SOLICITATION ADDENDUM NO. 2

Project Title	Date Prepared	Project No.
SJCCD Maritime Expansion Fire Training Center	December 4, 2019	CSP 20-12

ADDENDUM NO. 02

Project: **Maritime Expansion Fire Training Center**
 San Jacinto Community College District

C1.01
 DEMOLITION SITE PLAN

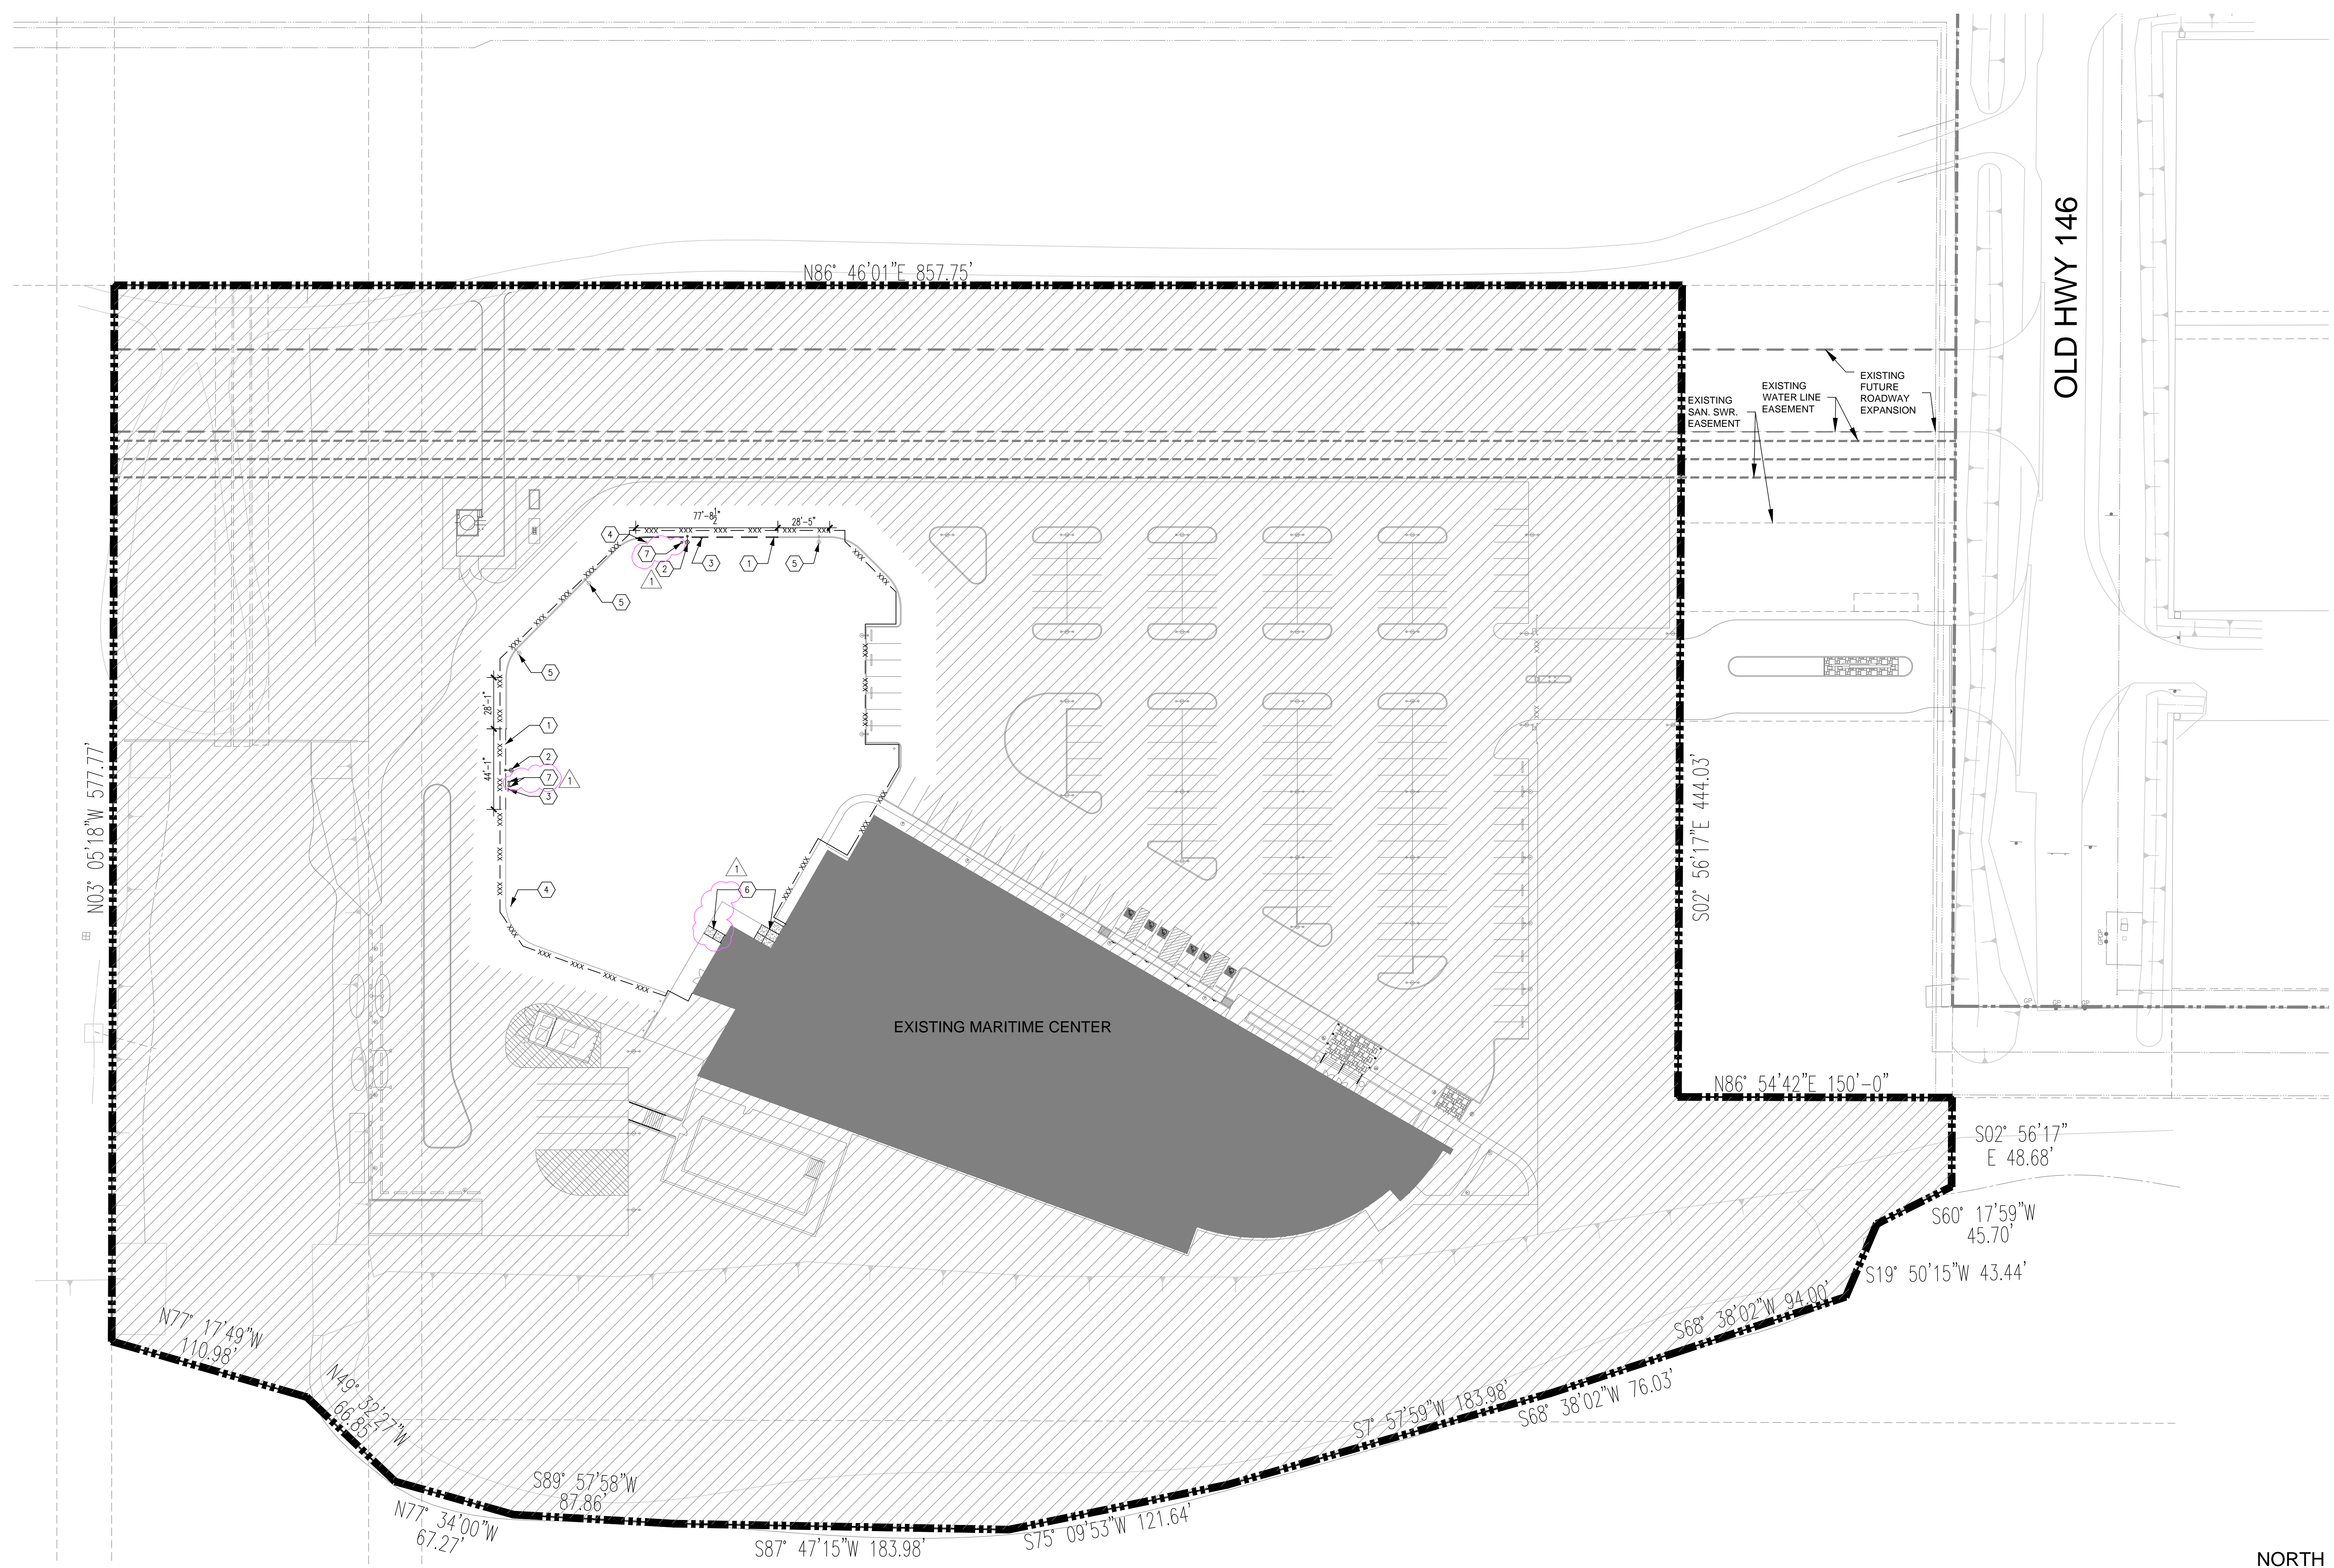
13. Sheet C1.01 – Demolition Site Plan
 - a. Portion of concrete to be removed next to the existing Maritime Center.
 - b. Keynote 7 has been added to remove and relocate existing electrical box.

RENOVATION SITE PLAN

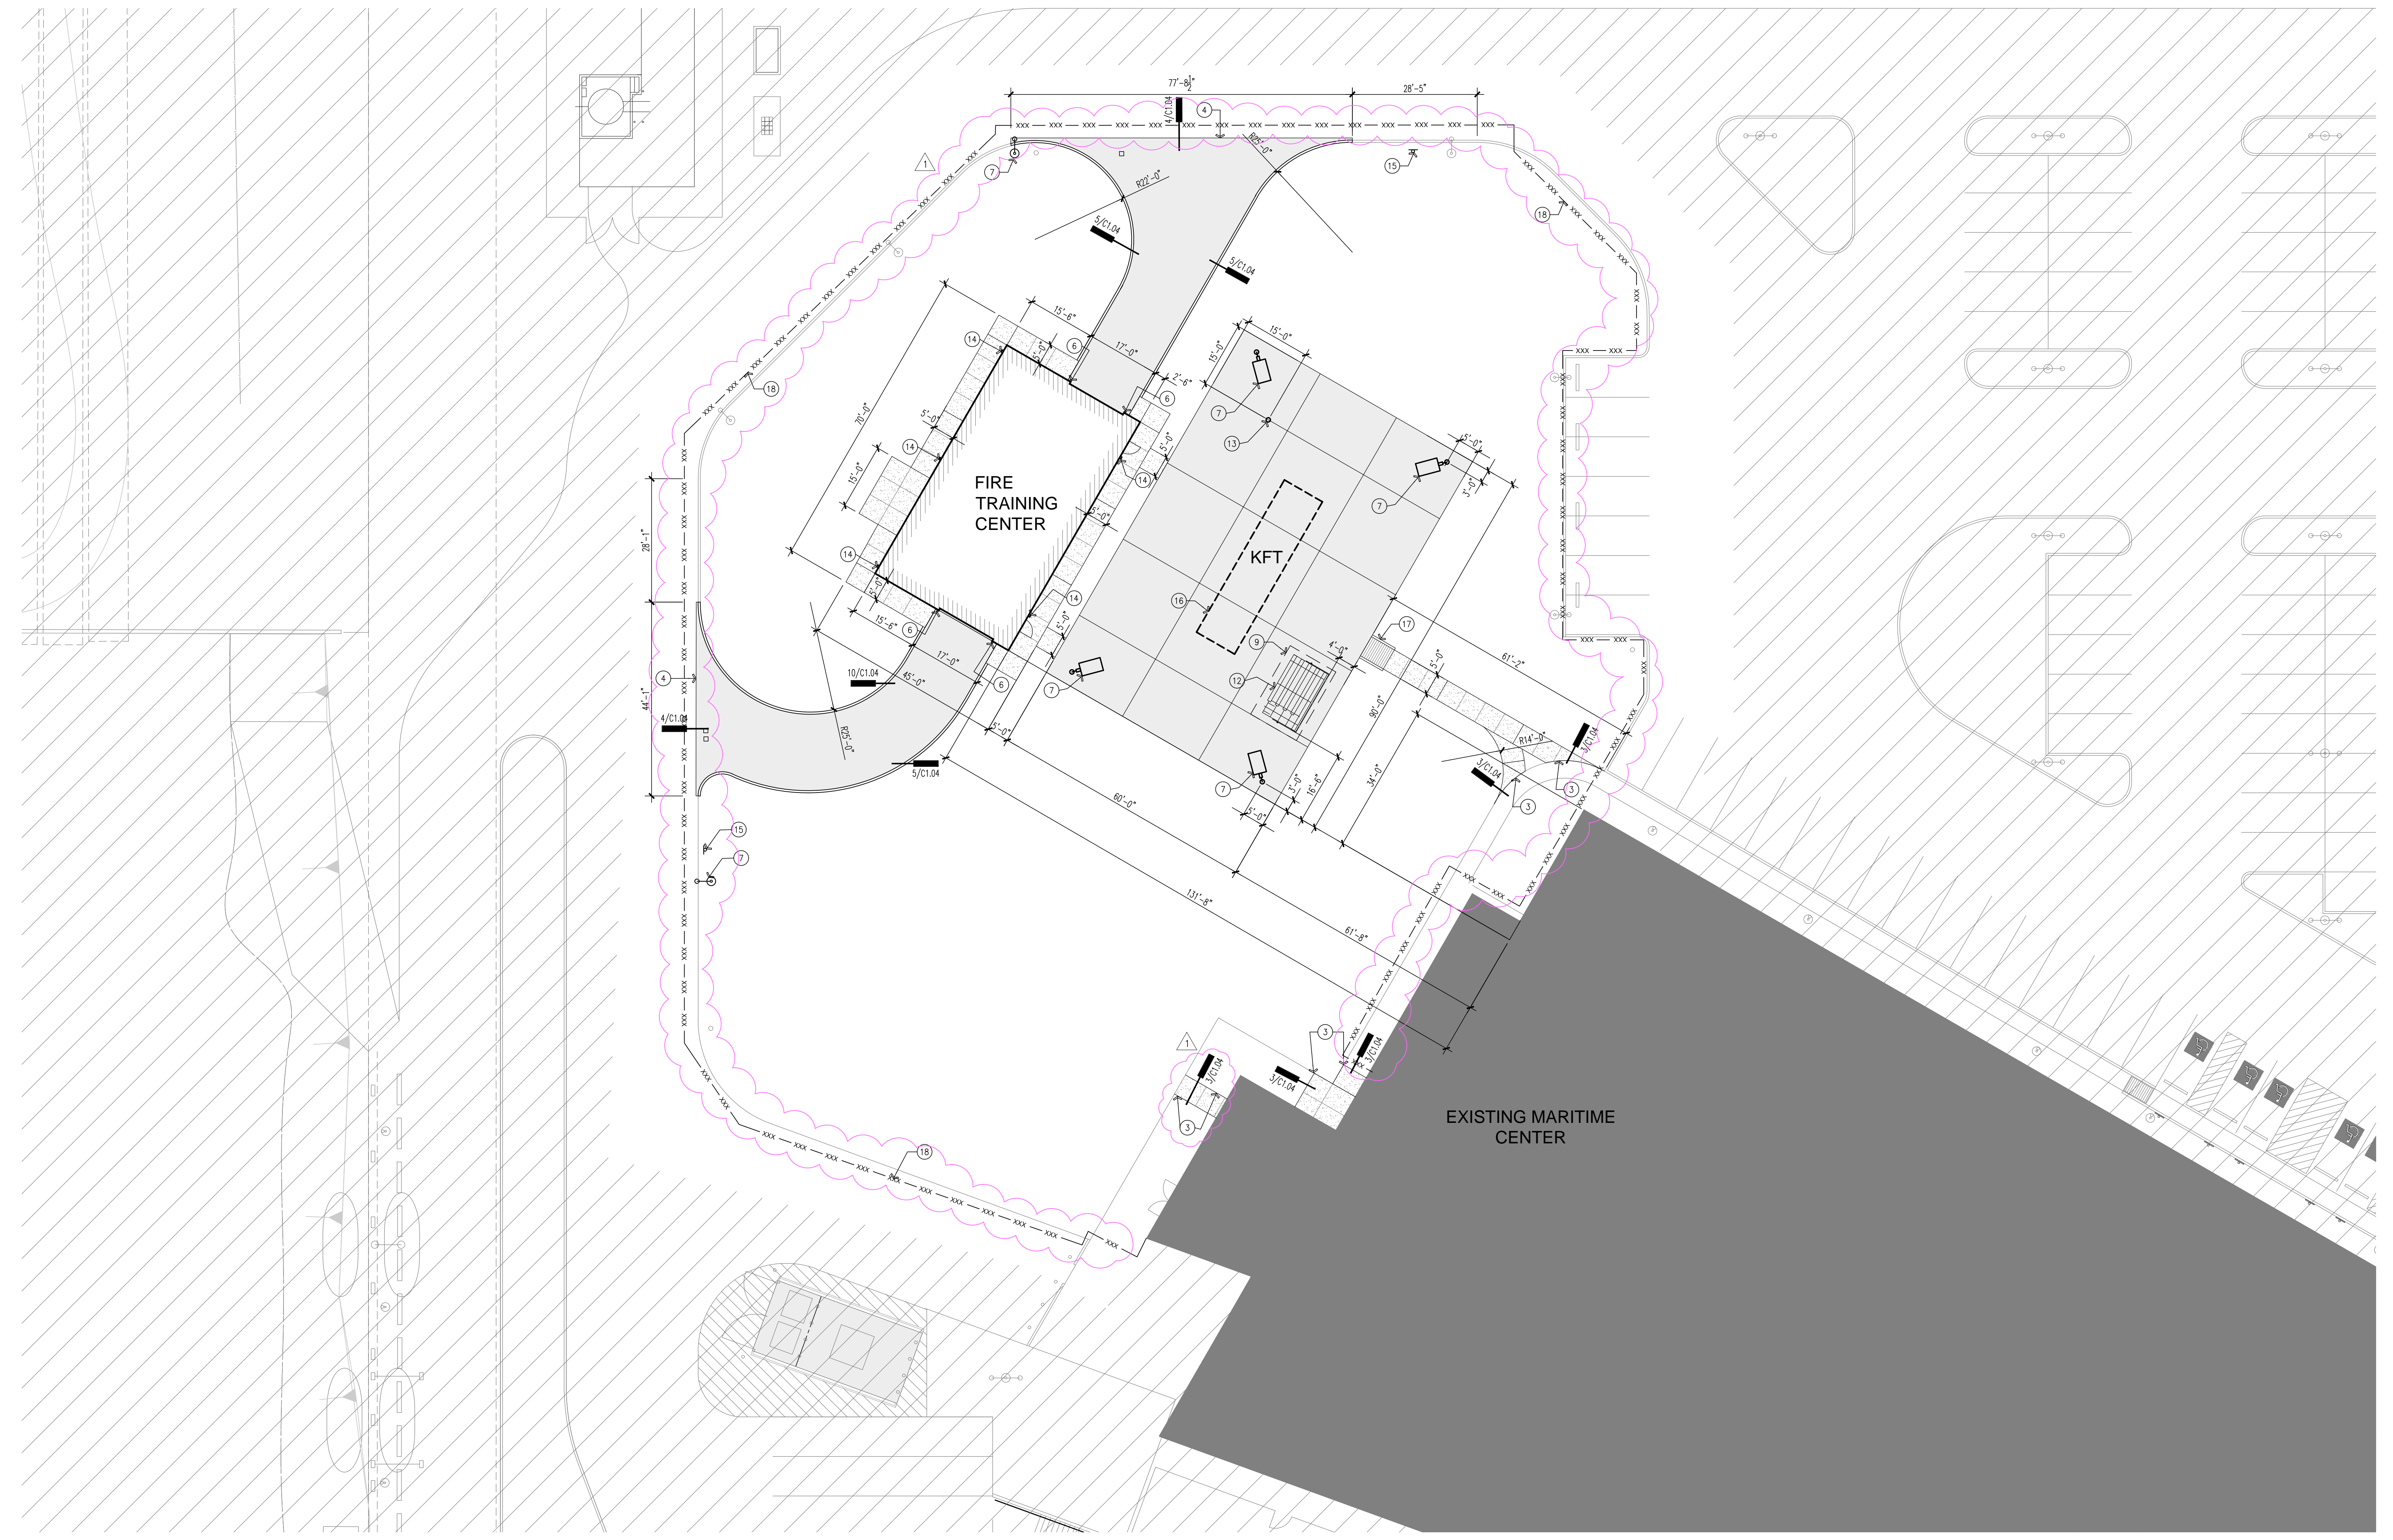
14. Sheet C1.03 – Renovation Site Plan
 - a. Portion of concrete walk is to be replaced and patched.
 - b. Construction fence to surround job site.
 - c. Keynote 16 has been revised for the KFT to be provided and installed by owner.
